## Church Street Parking (Library Square) Public Open House Summary

The Town of Aurora and the consultants hired on behalf of the Town (The Planning Partnership and BA Group) hosted a Public Open House on Thursday May 23<sup>rd</sup>, 2019 at the Aurora Public Library (15145 Yonge St, Magna Room). The purpose of the Public Open House was to provide information about the review process, introduce potential options to modify the Church Street right-of-way as part of the Library Square redevelopment, and seek feedback from the public.

**Figure 2: Option 1**

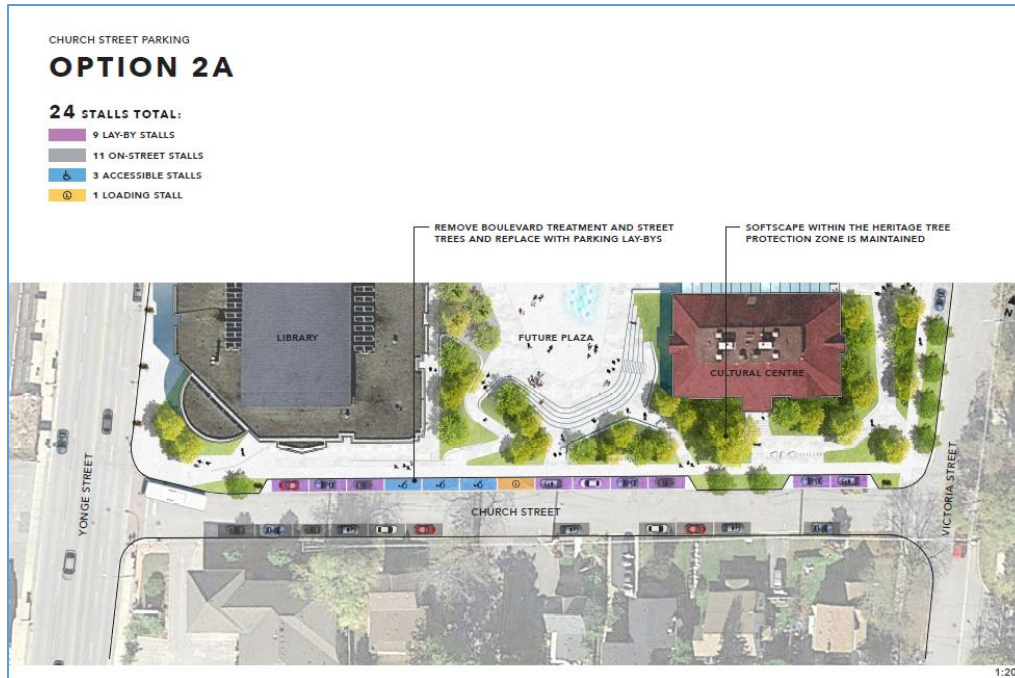
- This option is preferable as it maintains the existing street trees;
- Consider a secondary entrance to the south-east corner of the library for easier access from Church Street;
- Widen the intersection at Yonge Street and Church Street to accommodate bus turning movements;
- Focus on changing behaviours and get people walking rather than adding more parking spaces for cars;
- Consider converting on-street parking on Yonge Street to a 15-minute drop off to take advantage of the accessibility ramp connecting to the west entrance of the Library; and
- Make sure there are enough drop-off spots per building (Library, Cultural Centre, and the new Community Facility).
